LYNK Solar Gateway – DC-DC Power Supply

| CSB Number | 855-0011 Rev A |
| Date | MAR 22 2022 |

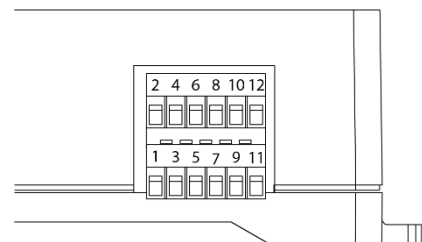
Later build of LYNK Solar Communication Gateway (950-0015) does not include a DC-DC Power Supply (950-0019). The following note from the LYNK Solar Manual is now incorrect as the 950-0019 DC-DC Power Supply is discontinued and not available.

Product discontinued.

Replace the LYNK Solar (950-0015) with a LYNK II Communication Gateway (950-0025) for

- 42-48-6650 with a serial number before DET424820275xxxx
- 44-24-2800 with a serial number before DET442420225xxxx

The LYNK II can receive power from the battery terminals to the Phoenix connector terminal PINs 7 & 9:
